Detailed Site Plan Major Departure Alternative Compliance Allora Brandywine 2.0

DET-2022-003
MJD-2022-001
ACL-2023-002

STAFF REPORT

SUBJECT: Detailed Site Plan DET-2022-003
Major Departure MJD-2022-001
Alternative Compliance ACL-2023-002
Type 2 Tree Conservation Plan TCP2-133-91-17
Variance to Section 27-4204(d)(3)
Allora Brandywine 2.0

Figure 4: Permanent Real Estate Identification Sign Architectural Elevations

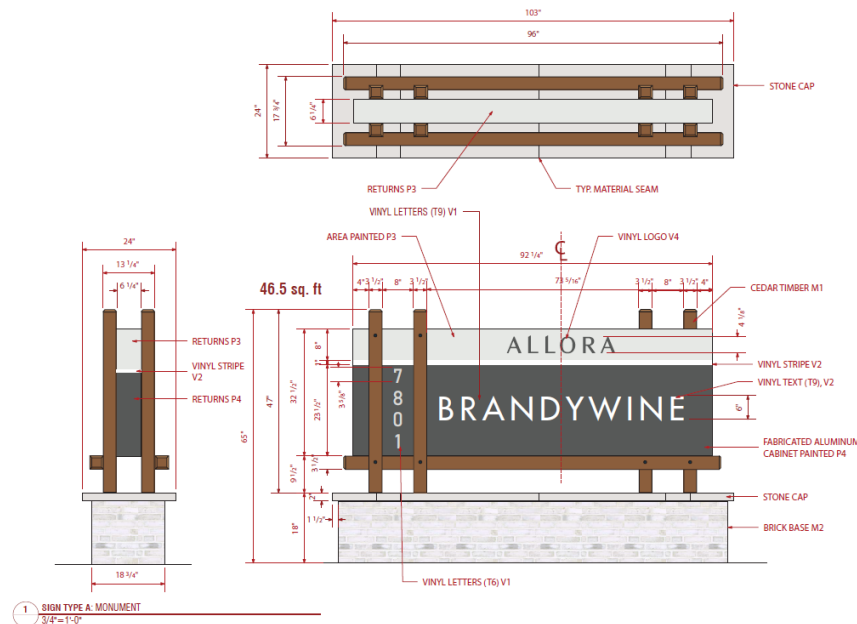
3. **Signage.** The applicant has provided a signage plan and signage schedule on the DET coversheet for the site. One freestanding, permanent real estate identification sign is proposed between the median of the site's access point, along Matapeake Business Drive. The sign will be approximately 5.5 feet tall by 7.5 feet wide and ground-mounted on a brick base, which will match the building color and materials. Static lighting will be provided, with light being directed toward the sign.

The applicant also identifies other signage proposed for the property. This signage includes identification signs for tree conservation areas, the locations of specific types of parking spaces, building addresses, and breezeway identification.
